CPED STAFF REPORT

CPC Agenda Item #3
March 3, 2014
BZZ-6427

Property Location: 5025 Knox Avenue S
Project Name: Mount Olivet Entrance/Elevator Addition
Prepared By: [Kimberly Holien](#), Senior Planner, (612) 673-2402
Applicant: Mount Olivet Lutheran Church
Project Contact: Paul Humiston, Paul Meyer Architects, (763) 557-9081
Request: To construct a 1,400 square foot addition to the west side of the existing building.

PROJECT DESCRIPTION. The applicant is proposing a 1,400 square foot addition on the west side of the existing building. The addition will include an accessible entrance into the Narthex and a new elevator and stairs and will be constructed of materials matching the existing building. The addition will result in alterations to two west-facing building entrances. As part of the project, the applicant is also proposing a number of alterations and improvements to the parking lot. The parking lot currently has six curb cuts on Logan Avenue S and one on 50th Street W. The proposed project will reduce the number of curb cuts to two, one from the main parking area and one from the overflow parking area along the south property line. The parking lot would also include two c

INFILTRATION BASIN TYPICAL SECTION
SCALE: N/A

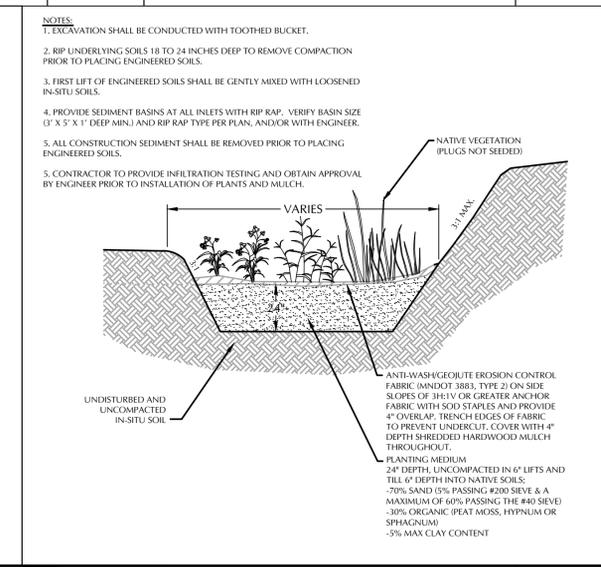
- It is recommended that a detail be provided for the underground infiltration system on the plans.
- The precipitation and temperature files used in the P8 model should be appropriate for the project location. Typically, the City water quality requirements are evaluated for a 1.25" rain event.
